BUILDING CODE OF AUSTRALIA CAPABILITY STATEMENT - Rev A

Property/Project: Sydney Opera House Lower Concourse Improvements – Bennelong Point, Sydney

Re: ACCESSIBILITY CAPABILITY STATEMENT AT SSDA STAGE – Rev A

Figure 1 – Part Existing Lower Concourse Fire Rating Plan

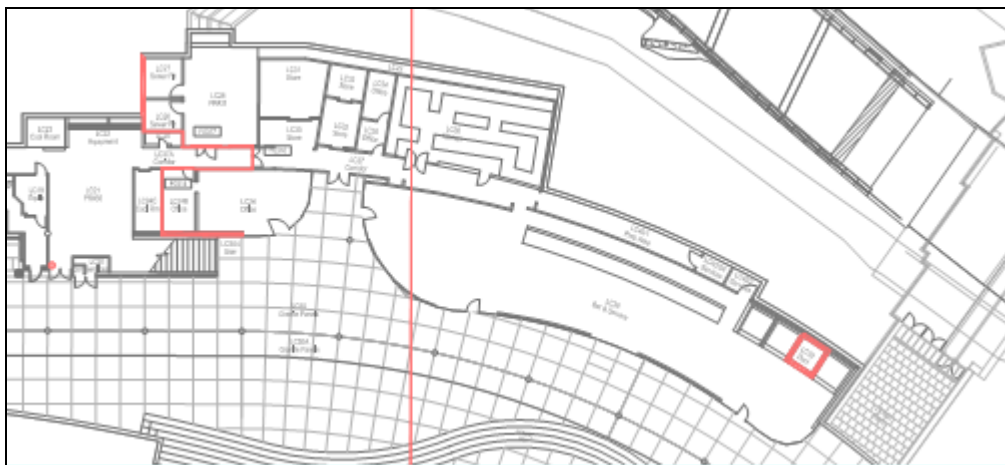
The relevant existing Arup Fire Compartmentation plan (Fire Compartments and Fire Door – Level LC 2015 Audit dated 19-09-2016, see Figure 1 below) is noted as “Level not yet reviewed.” This plan will need to be finalised prior to the issuance of the Crown Building Works Certificate. Section 5 of the Arup Compartment Review dated 22 September 2016 suggests that these walls may contain a fire rating of 120/120/120. Whilst we recognise that the compartment review of this area is incomplete, the finalisation process should also look at the existing level of fire rating as the current BCA would require these walls to achieve 180/180/180 rating. Relaxations of existing fire rating levels may already exist in current fire engineering reports. This would also need to be considered at the time of finalising the existing compartmentation plan for this storey.
